ADDENDUM NO. ONE (1)
CITY OF STATHAM, GEORGIA
OAK STREET SPRING IMPROVEMENTS
ISSUED March 27, 2026

RE: OAK STREET SPRING IMPROVEMENTS
EMI PROJECT No. 24-012

This Addendum forms a part of the Contract Documents and Drawings and modifies the original bidding documents dated FEBRUARY 2026.

M2

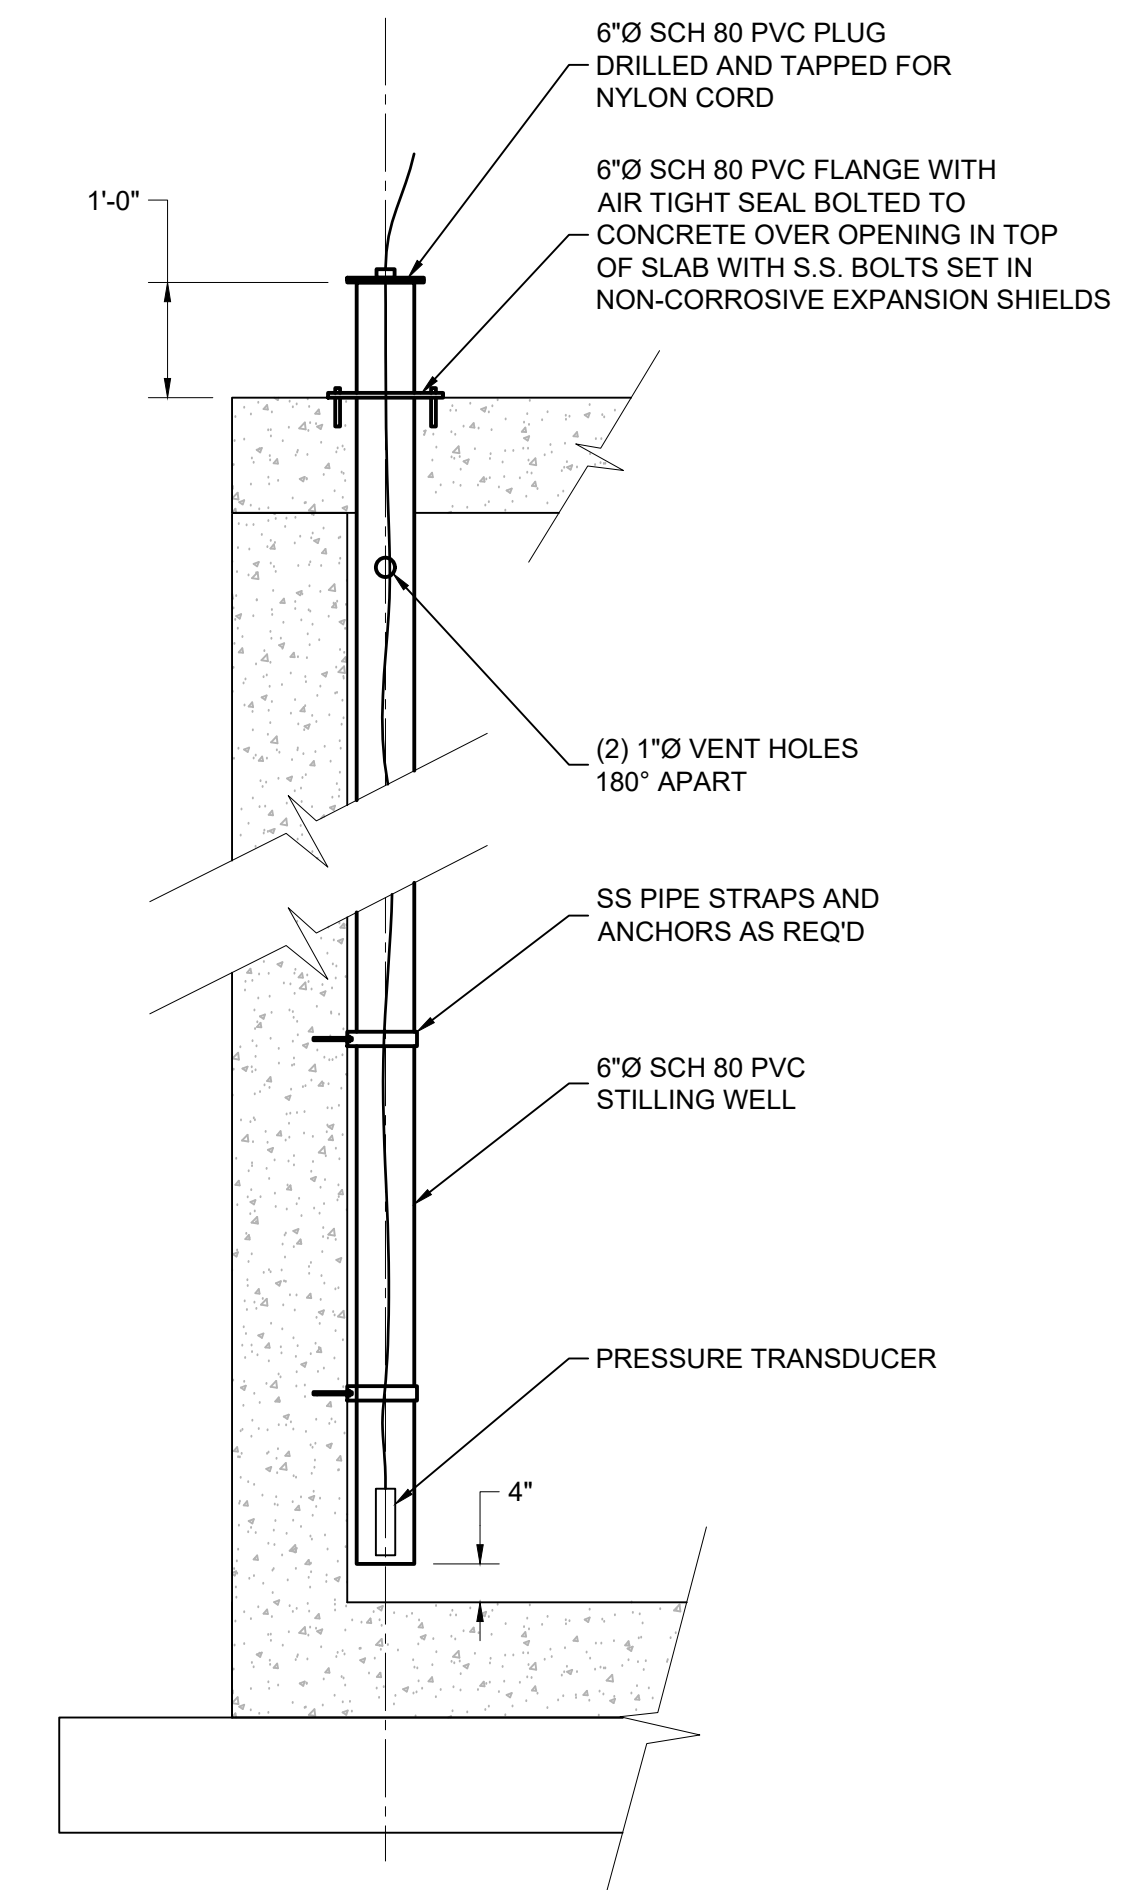
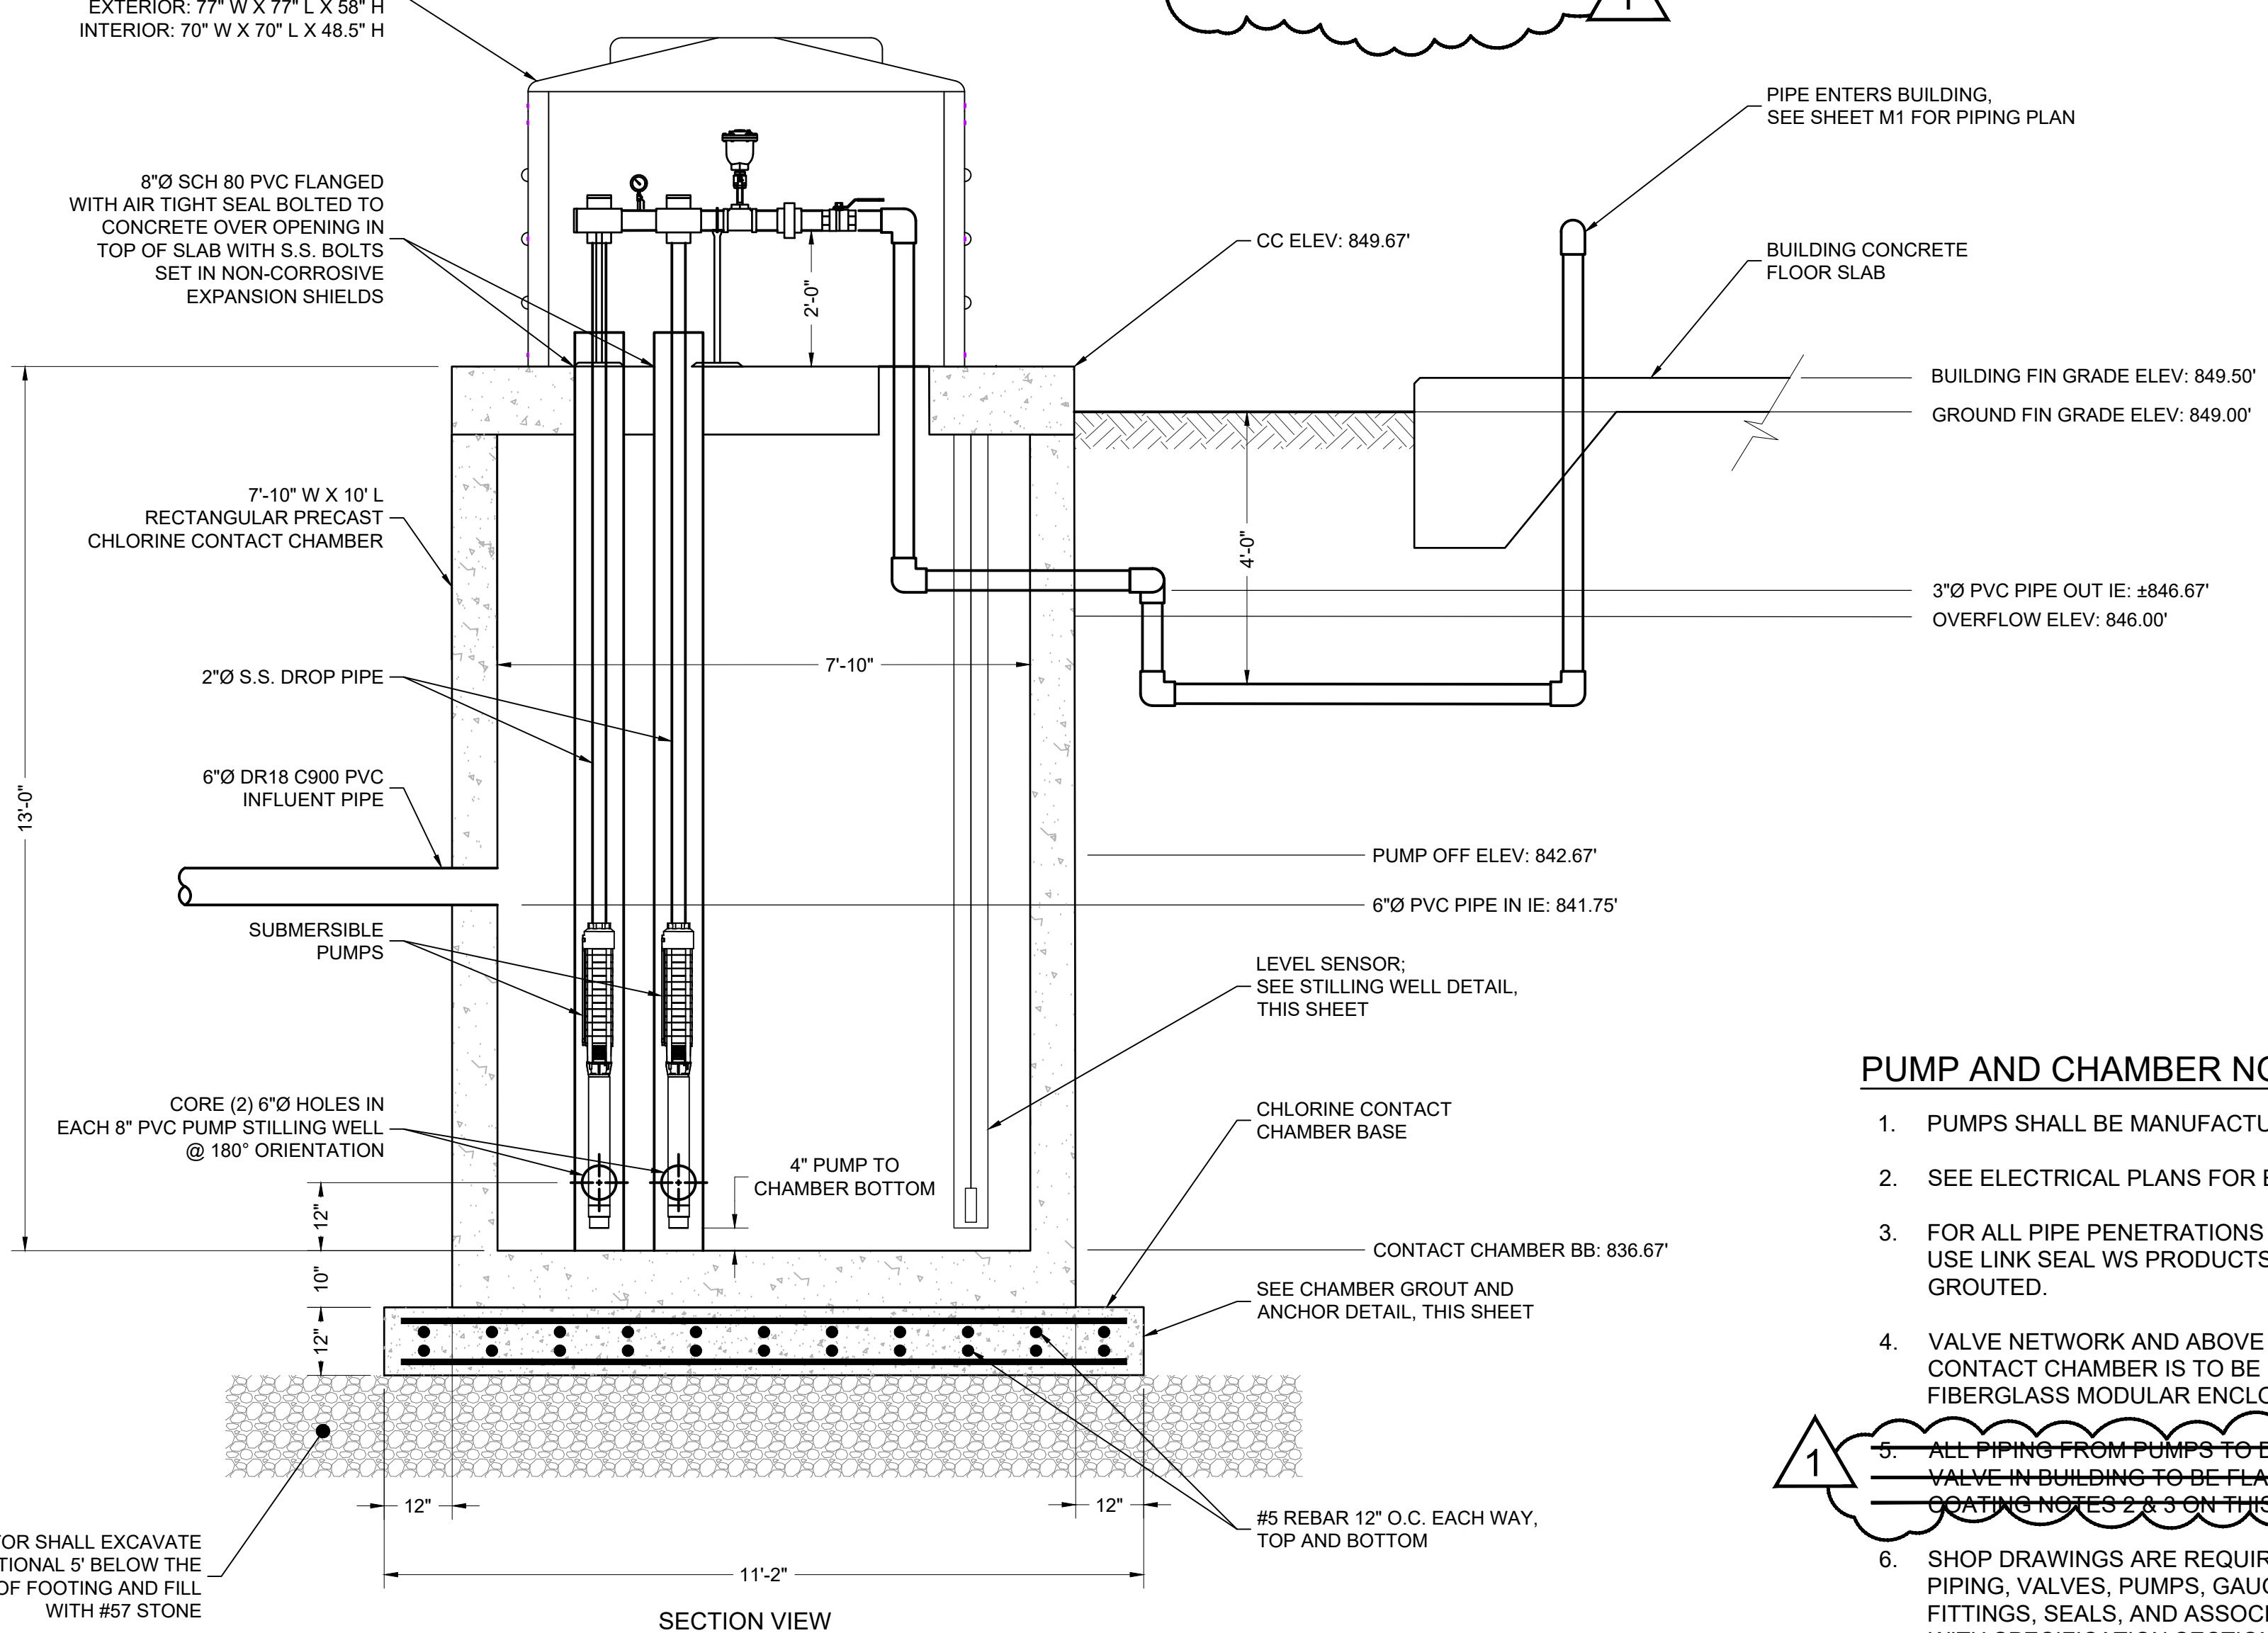
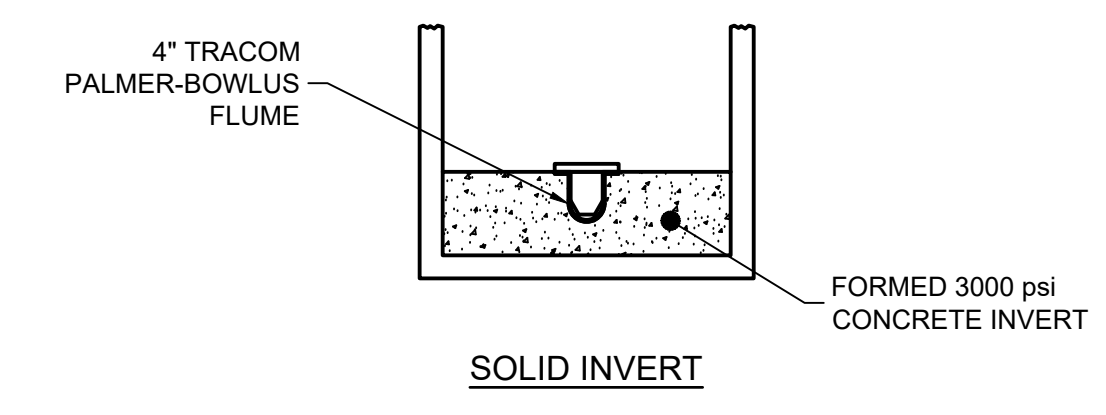
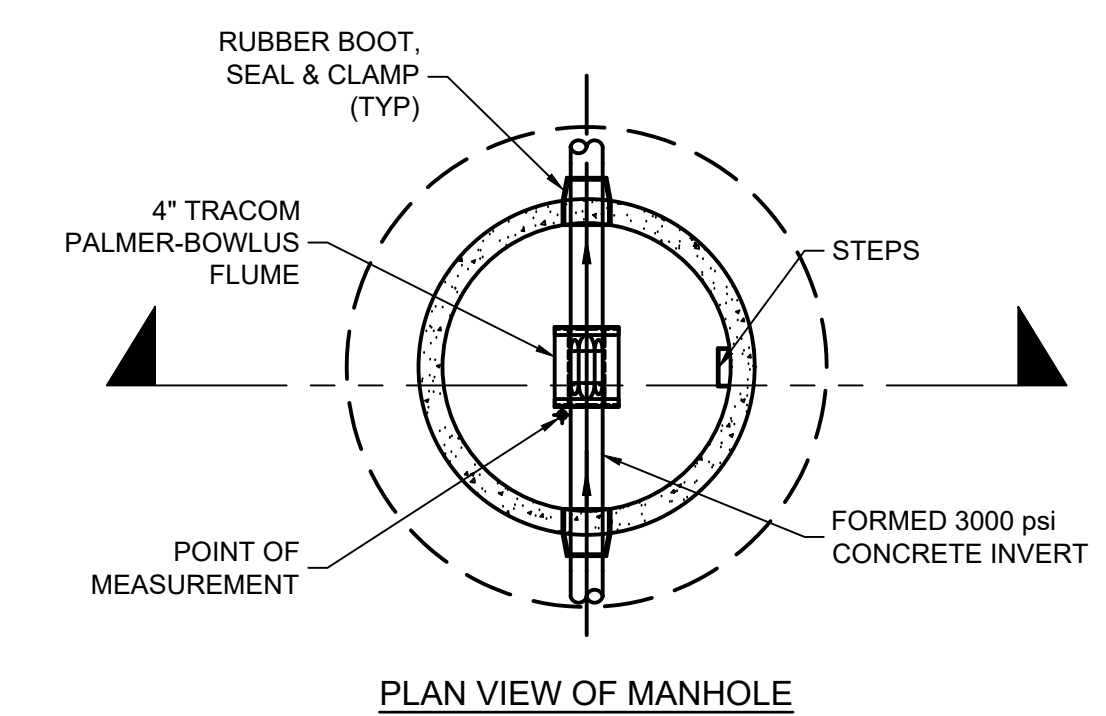
- Plan sheet M2 has been revised as follows. See attached revised plan sheet. (revisions are shown with revision clouds)
 - **The clearwell hatch has been changed to a flood tight 30"x30" clear opening hatch.**
 - **Pump and Chamber Note 5 has been removed as none of the piping is DIP.**
